2018 - 2019 Cadillac ATS-V - CTS-V: Service Bulletin: #20-NA-054: Rear View Camera Guidance Lines Dim After Radio Replacement or Programming

#20-NA-054: Rear View Camera Guidance Lines Dim After Radio Replacement or Programming - (Mar 3, 2020)

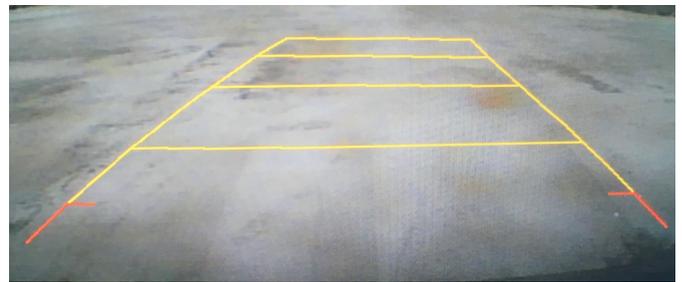
Original design:

New design:

This may be caused by installing calibration files released in mid-2018 during radio replacement or reprogramming of the radio. The change to increase translucency was done to prevent the lines from

obstructing objects in the field-of-view.

Do not attempt repairs. The thinner, lighter appearance of RVC guidance lines is operating to design intent.
